MX84B0**SF* Connectors with R at the base of the lock lever actuator

MX84B0SF* connector will have an R shape added at the base of the lock lever actuator to increase the strength of the lock lever.**

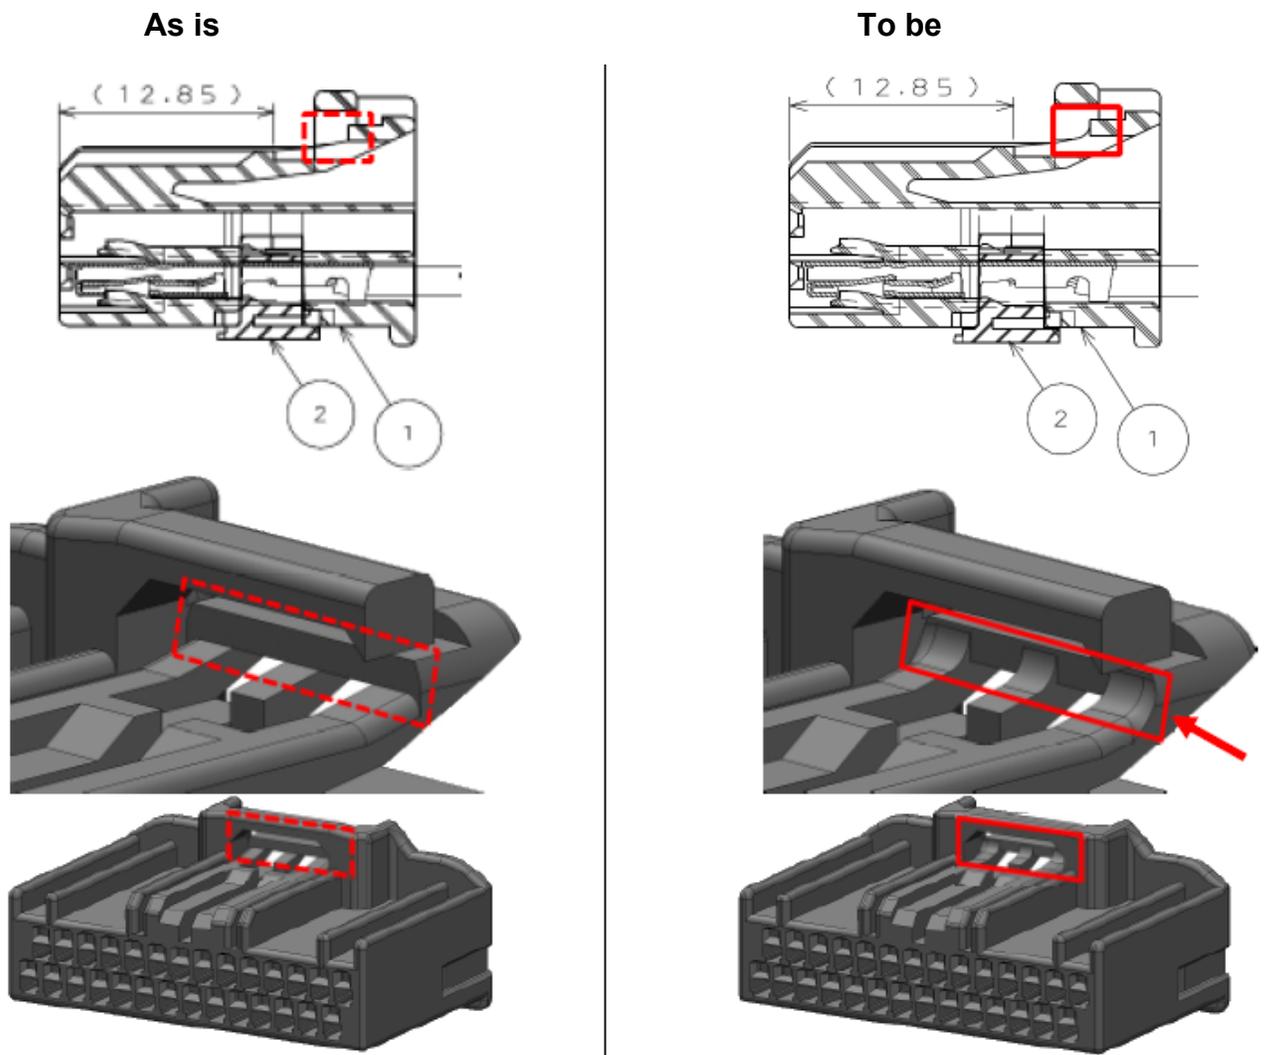
Add an R shape to the base of the lock lever actuator (red part) as shown in the table below. (Ex: MX84B028SF1)

There is no impact on the specifications and standards in the product specification JACS.
